BUILDING CODE OF AUSTRALIA COMPLIANCE ASSESSMENT REPORT

C2 – IVANHOE VILLAGE & COMMUNITY CENTRE

IVANHOE ESTATE – LOT C2, EPPING ROAD, MACQUARIE PARK

REPORT NO. ► 11067.2

Basement Level

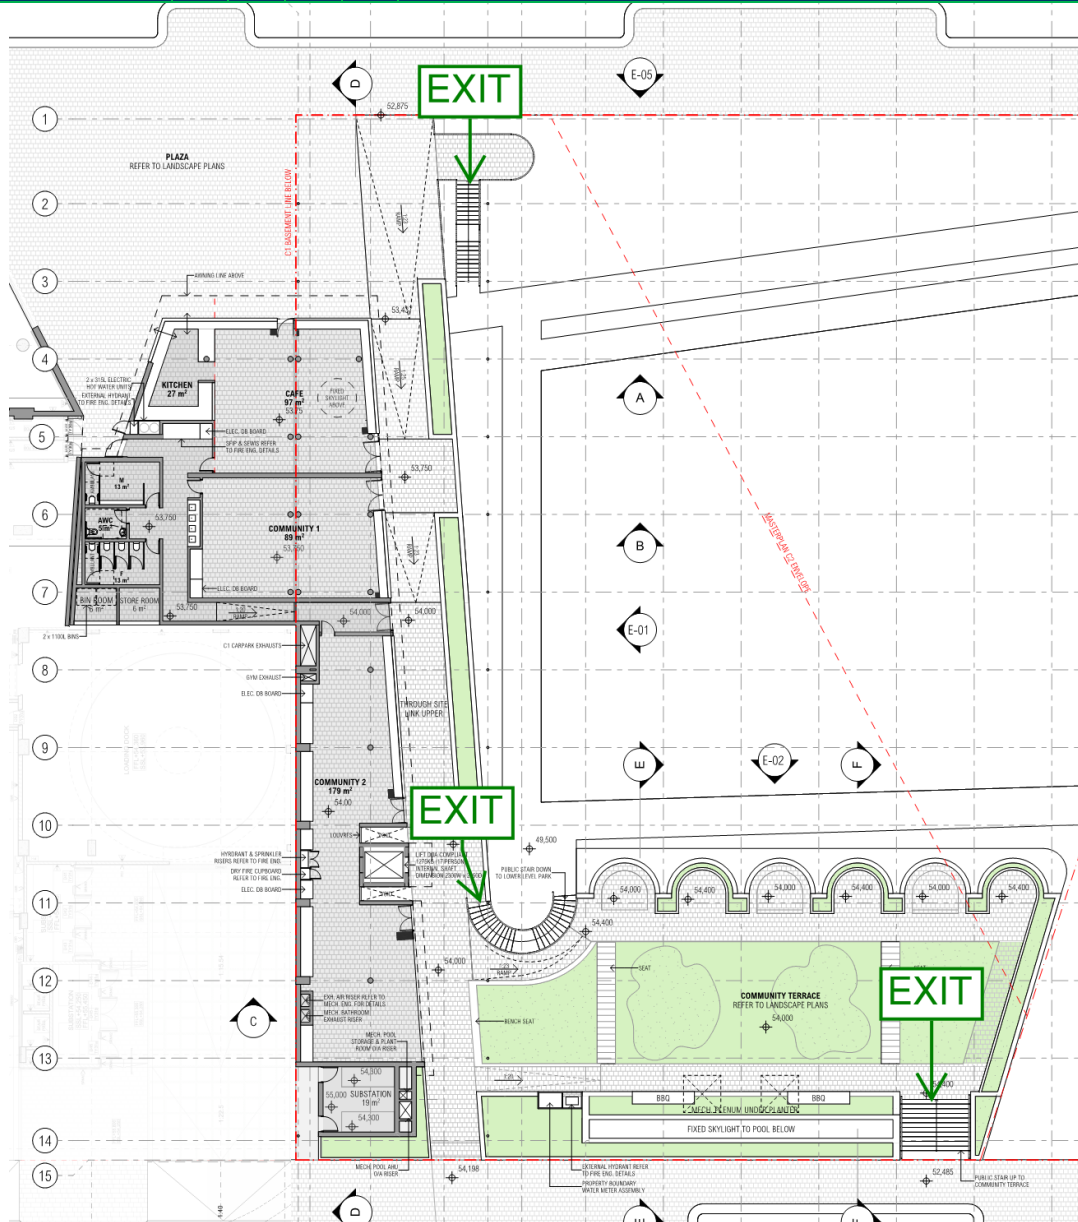
BCA DEEMED-TO-SATISFY PROVISION	COMPLIES	DOES NOT COMPLY	NA or Informational	Compliance Required	COMMENTS
					 <p>Lower Ground – Distance to a point of choice is less than 20m. Storey complies.</p> <p>Upper Ground – Distance to a point of choice is less than 20m. Storey complies.</p> <p><i>Details demonstrating compliance with this clause must be incorporated into the construction certificate plans / specification</i></p>
D1.5 Distance Between Alternative Exits		X			<p>Exits that are required as alternative means of egress must be—</p> <ul style="list-style-type: none"> (a) distributed as uniformly as practicable within or around the storey served and in positions where unobstructed access to at least 2 exits is readily available from all points on the floor including lift lobby areas; and (b) not less than 9 m apart; and (c) not more than— <ul style="list-style-type: none"> (iii) in all other cases — 60 m apart; and (d) located so that alternative paths of travel do not converge such that they become less than 6 m apart. <p><u>DTS non-compliance</u></p> <p>The distance between alternative exits from the plant are is more than 60m, being 88.1m.</p> <p><i>It is recommended this is addressed by a Fire Engineered Performance Solution.</i></p>

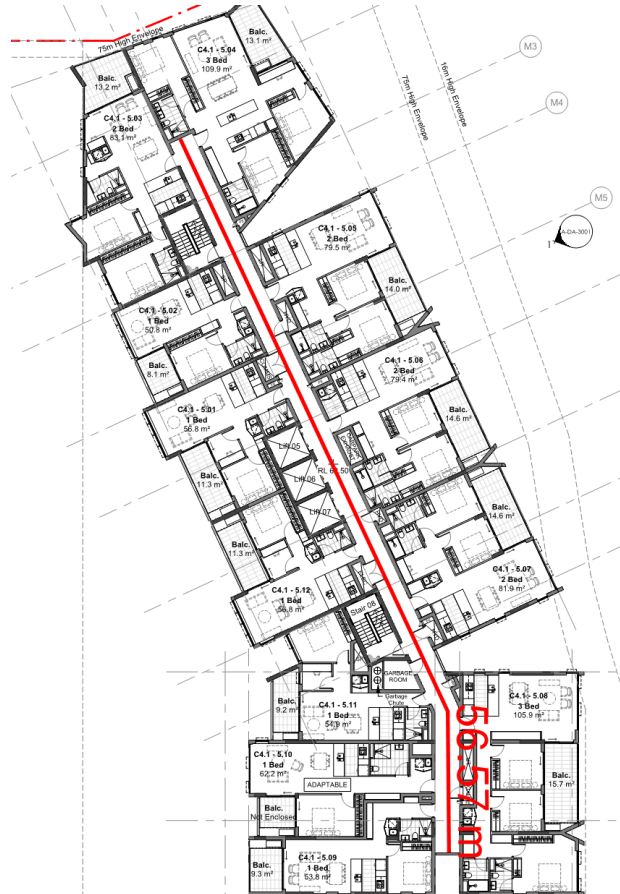
Level 1 & 2 - Corridor length is greater than 40m, being 47.32m

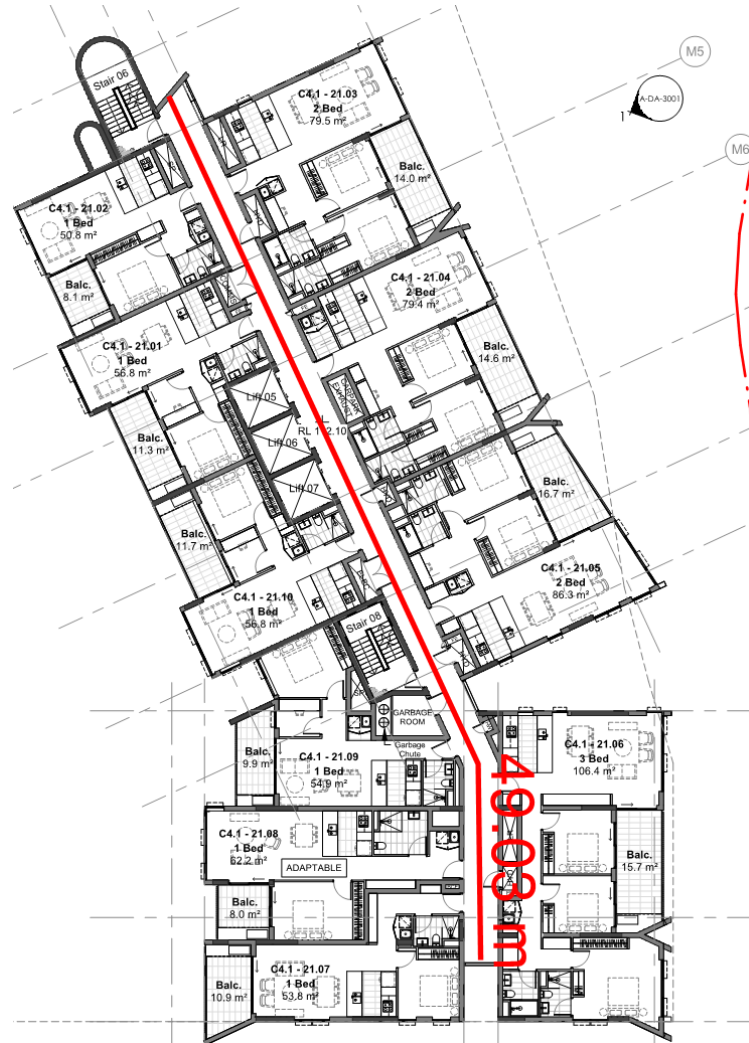
Level 3-17 Corridor length is greater than 40m, being 56.6m

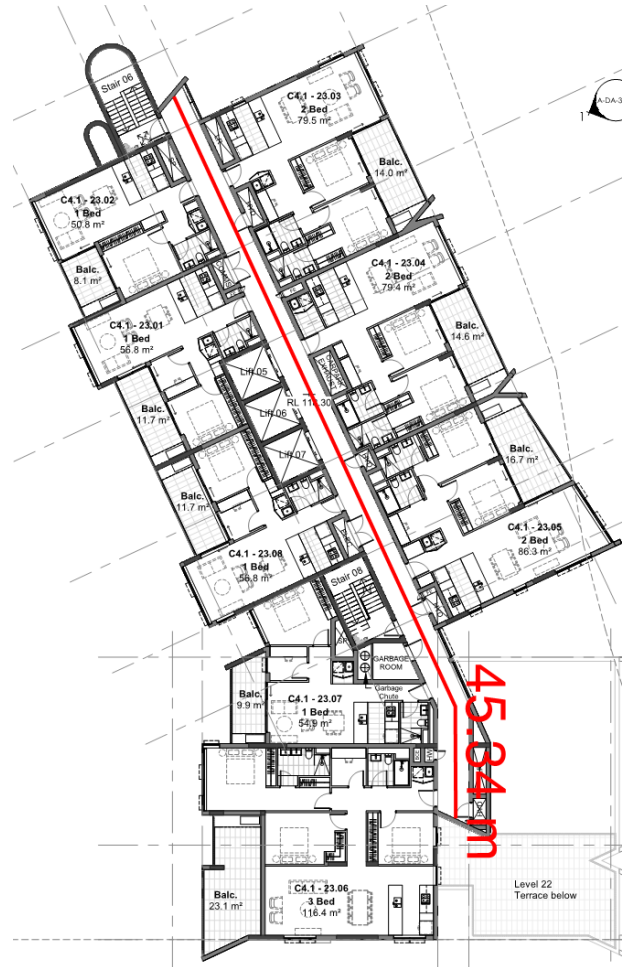
Level 18-21 - Corridor length is greater than 40m, being 49.1m

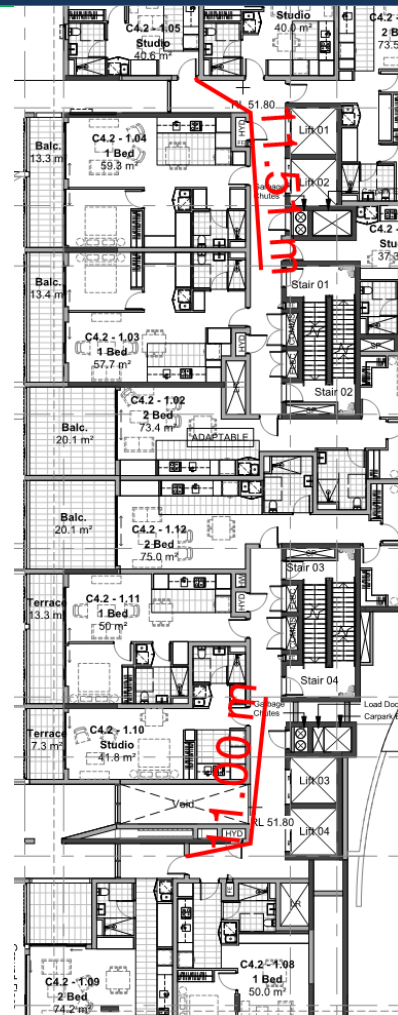
Distance to a Point of choice is more than 20m, being 27.49m

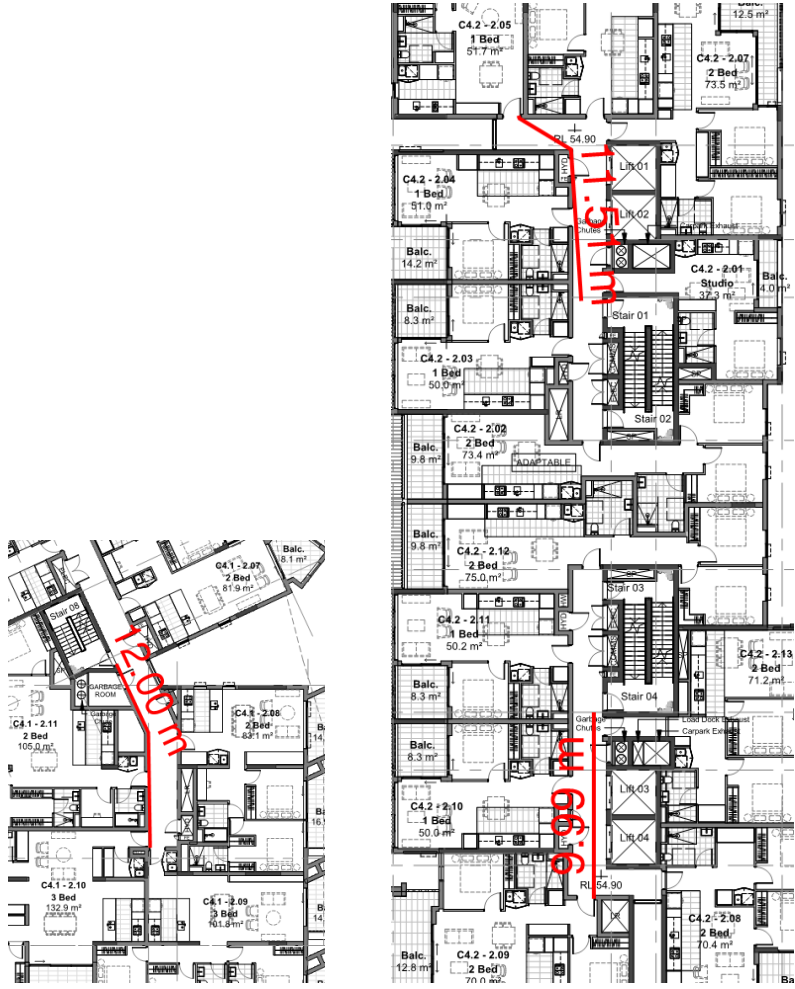
Distance between alternative exits is more than 60m, being 91.23m

Level 17-21

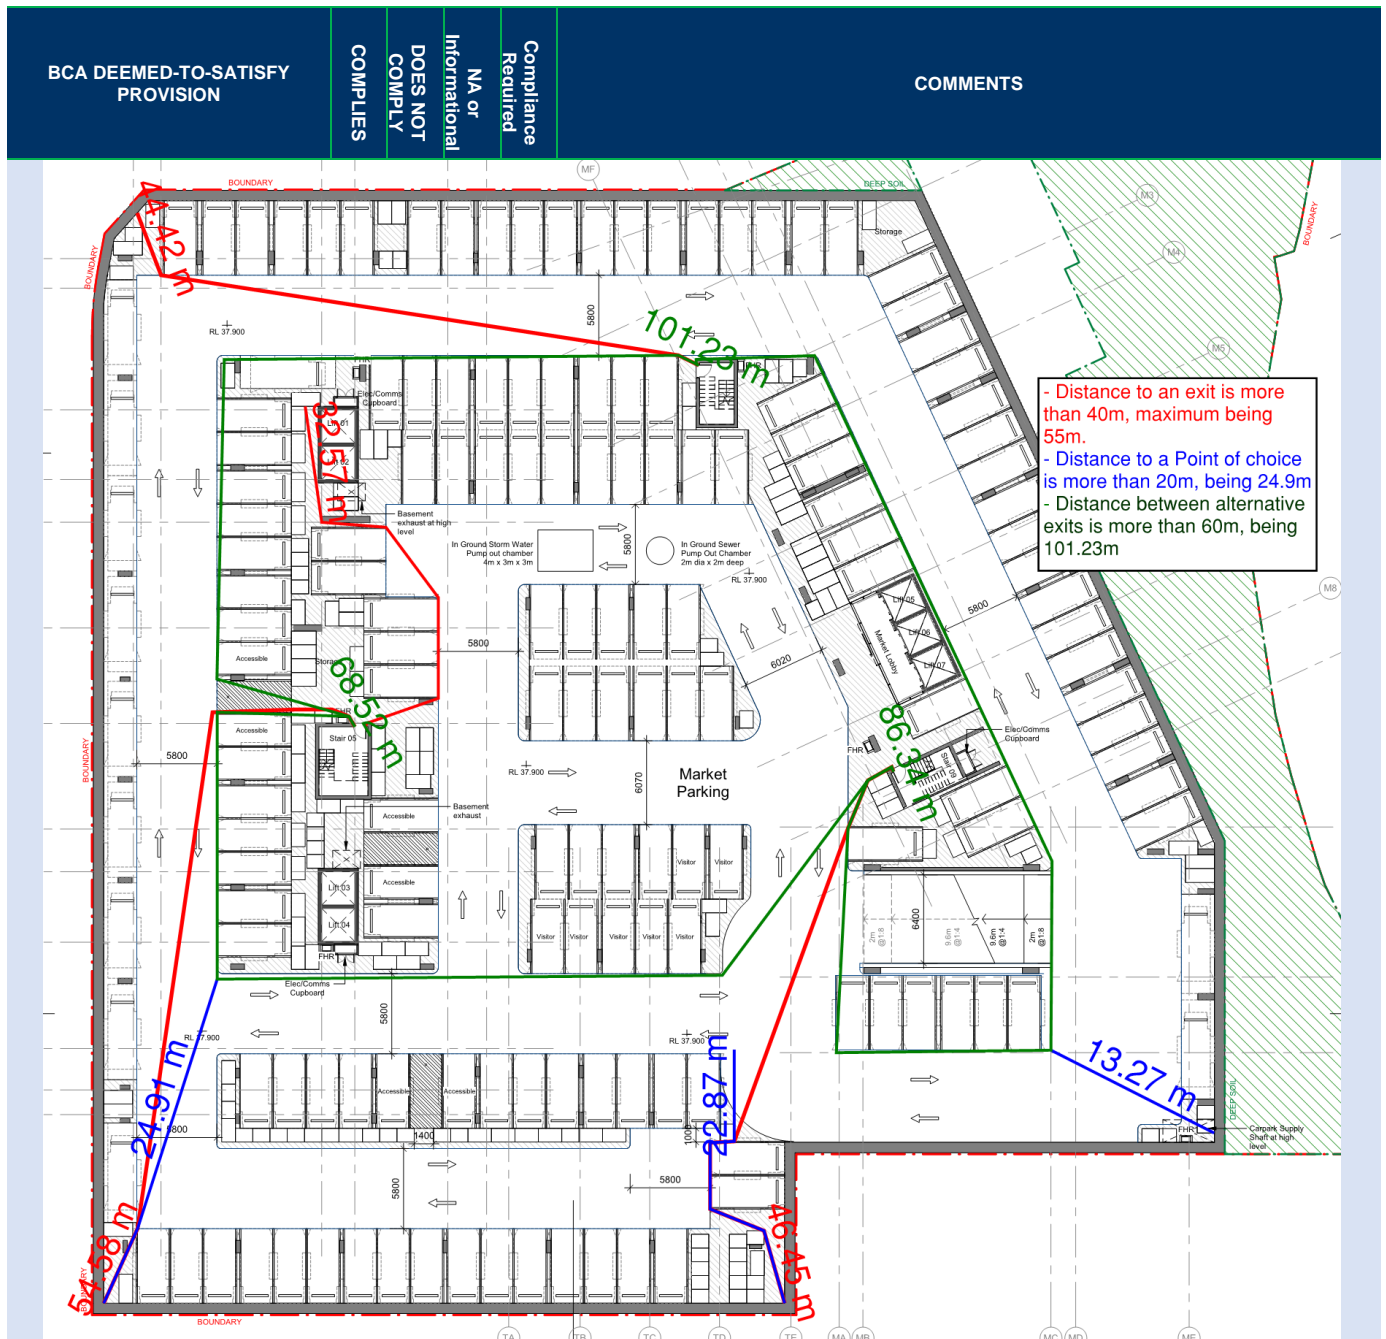
- Unit 17.04– The distance to a point of choice is greater than 6m, being 7.7m (shown in red below).
- Unit 17.09 - The distance to a point of choice is greater than 6m, being 11.7m (shown in red below)

Level 22-23

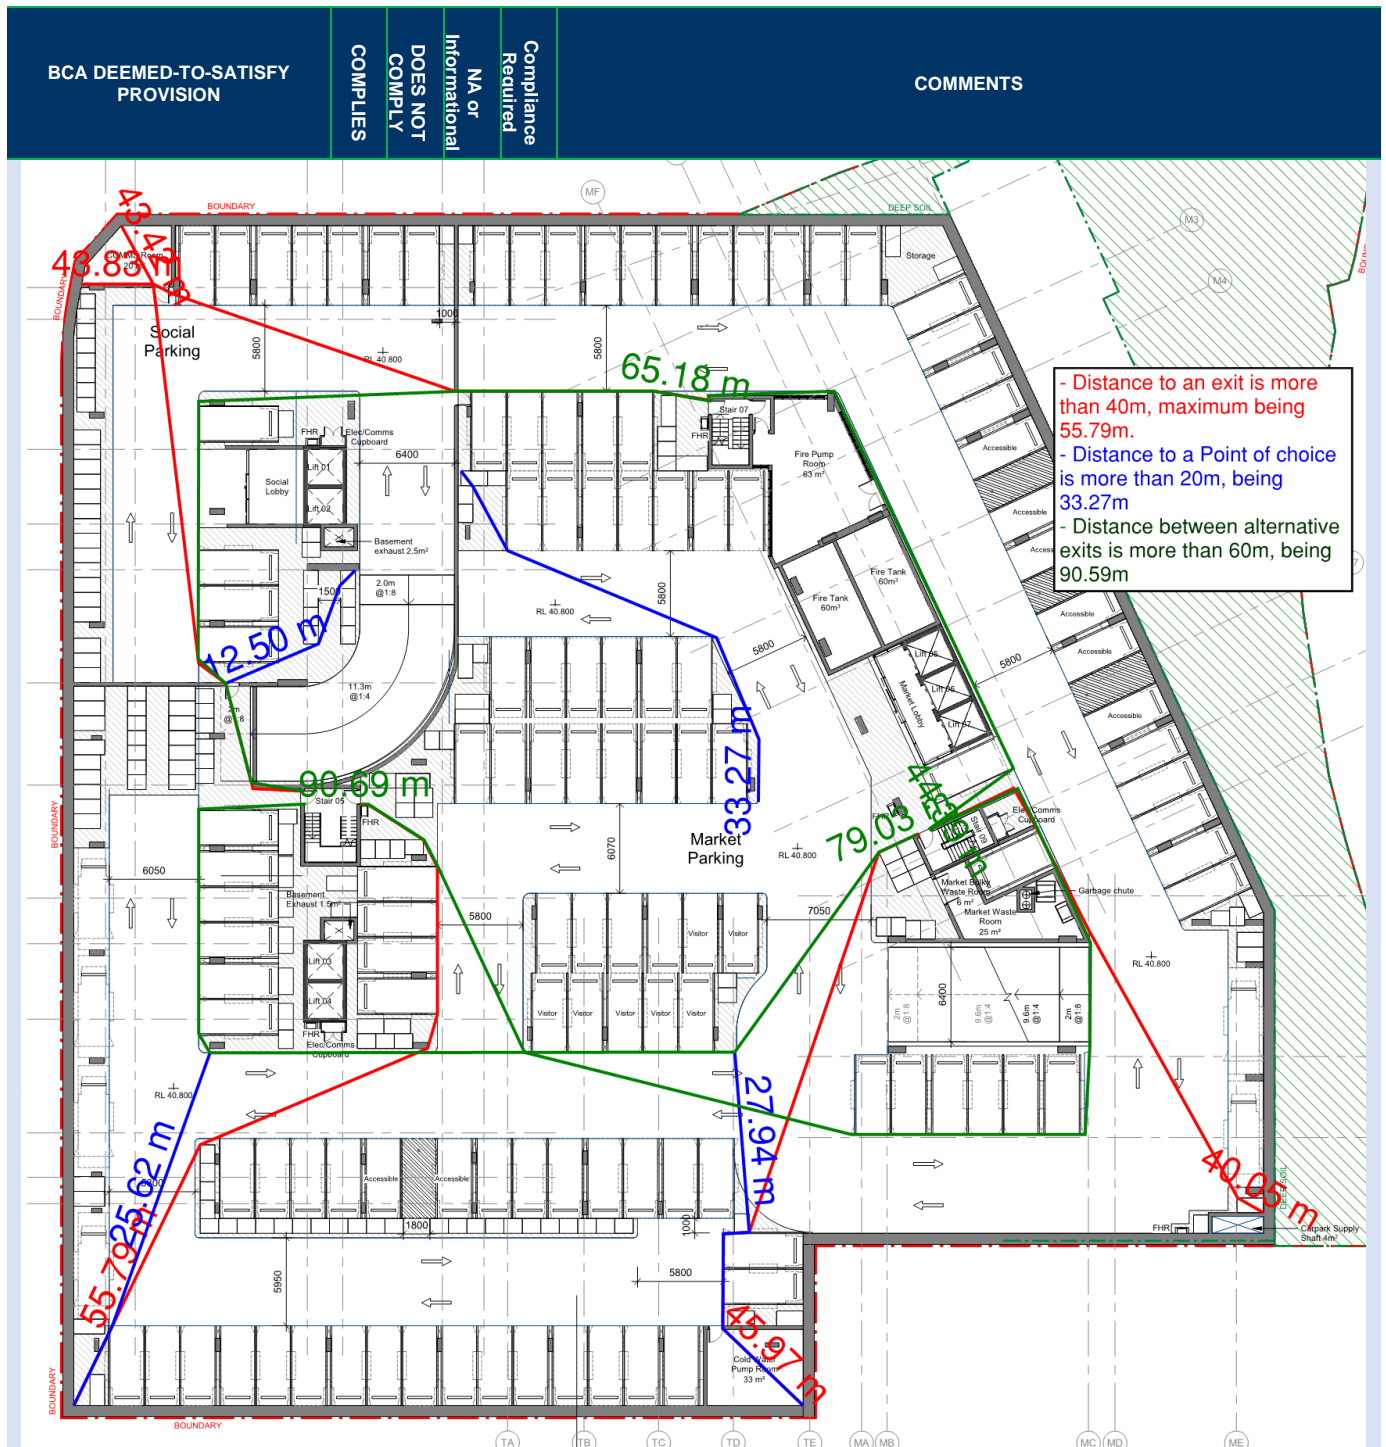
- Unit 22.06– The distance to a point of choice is greater than 6m, being 9.7m (shown in red below).

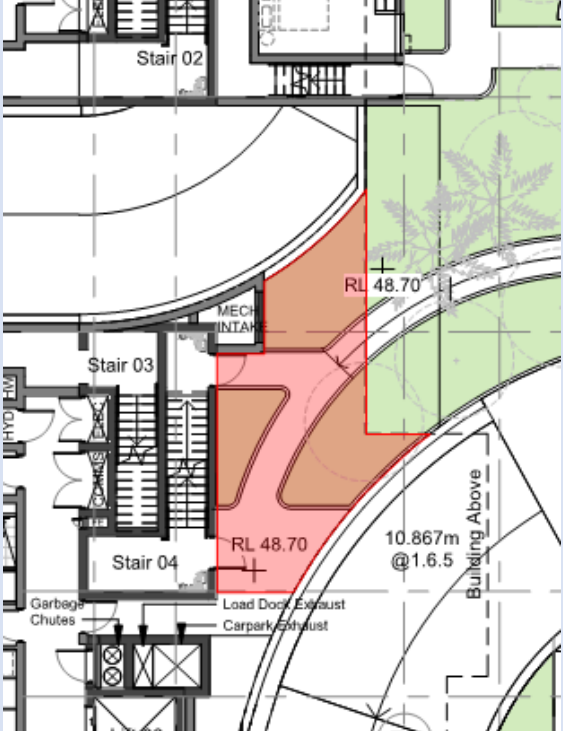
- Distance to a Point of choice is more than 20m, being 27.49m

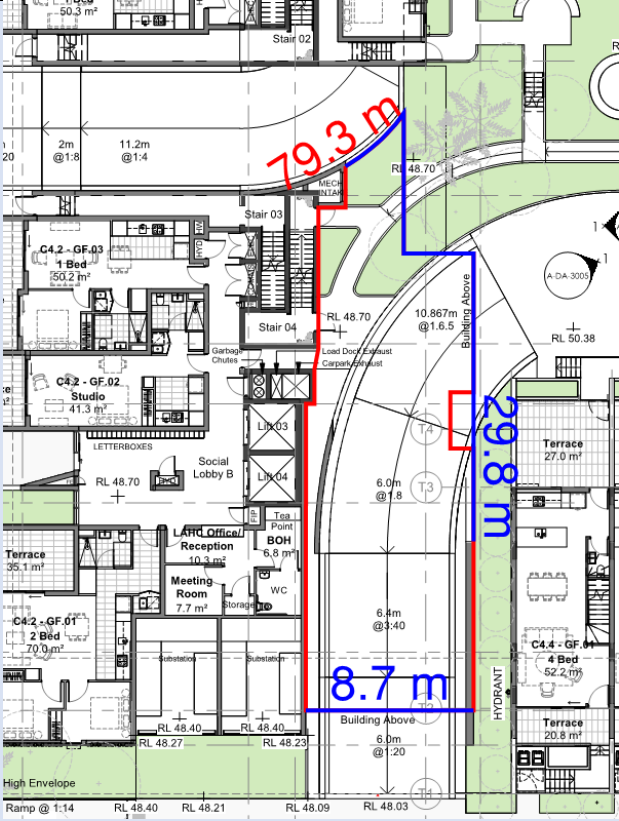
- Distance between alternative exits is more than 60m, being 91.23m

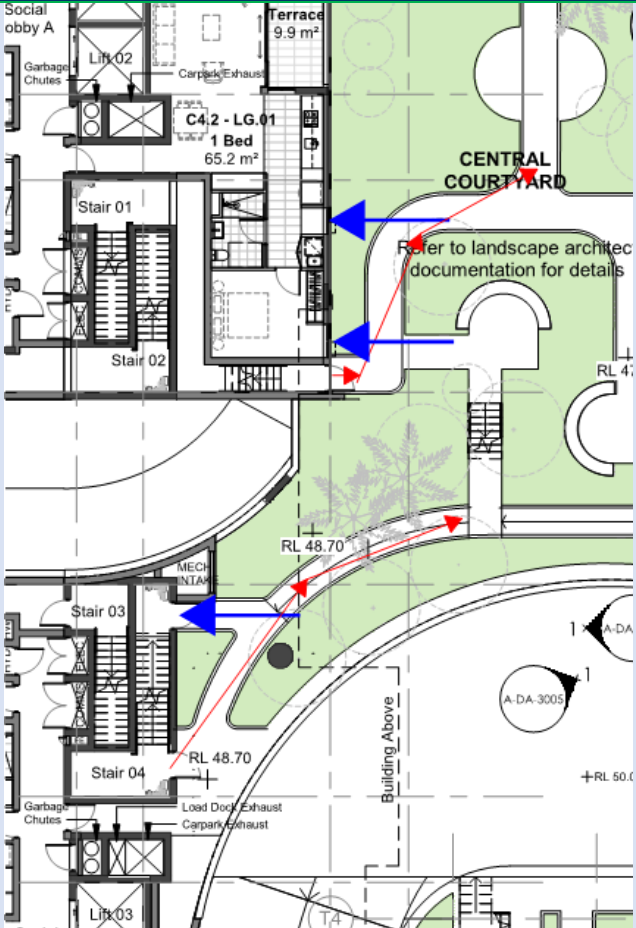
- **Between Stair 01 & Stair 02 – 5.18m**

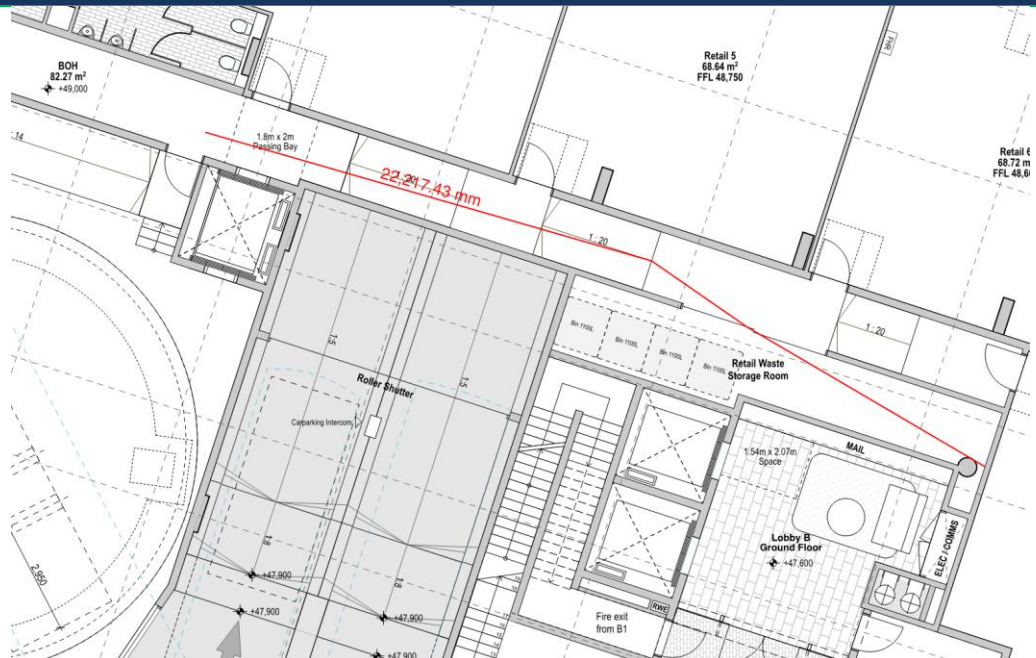
- Ground floor (Retail unit 1) – Up to 21.5m to a point of choice in lieu of 20m.
